AMENDMENT 1 AMENDEMENT 1

Household and similar electrical appliances – Safety –
Part 2-6: Particular requirements for stationary cooking ranges, hobs, ovens and
similar appliances

IEC 60335-2-6:2014/AMD1:2018

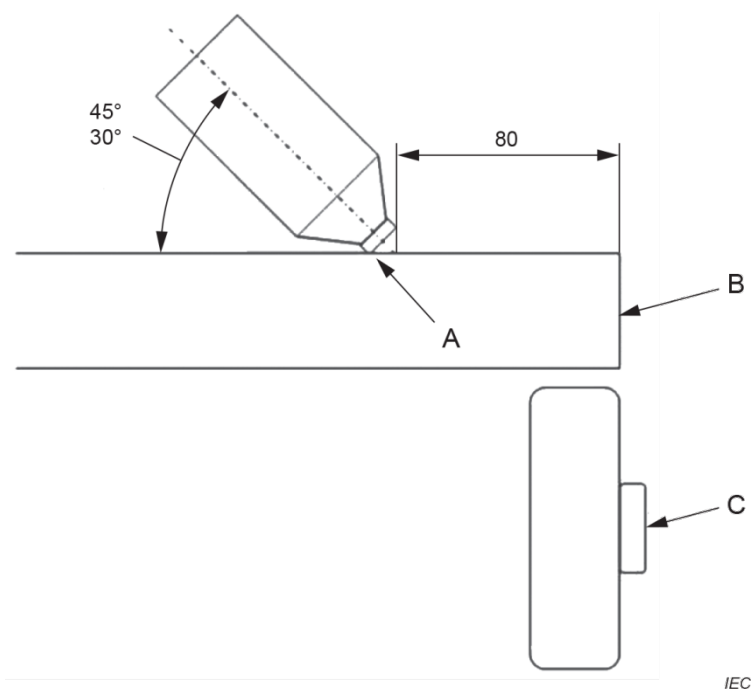
*The hole in the cap of the bottle is put on the horizontal work surface at approximately 80 mm horizontal distance with respect to the front of the **oven**. The inclination of the bottle shall be higher than 30° and lower than 45°. The lower part of the bottle hole in the cap shall be in contact with the work surface, with the hole in the cap placed down closest to the surface. See Figure 108.*

NOTE 101 The intention of the inclination and distance is avoiding the spillage “jumping” over the front of the **oven**.

When the 0,5 l of spillage solution has been poured, the remaining solution on the work surface is pushed towards the front so that the remaining solution spills homogeneously over the front with a suitably flat means.
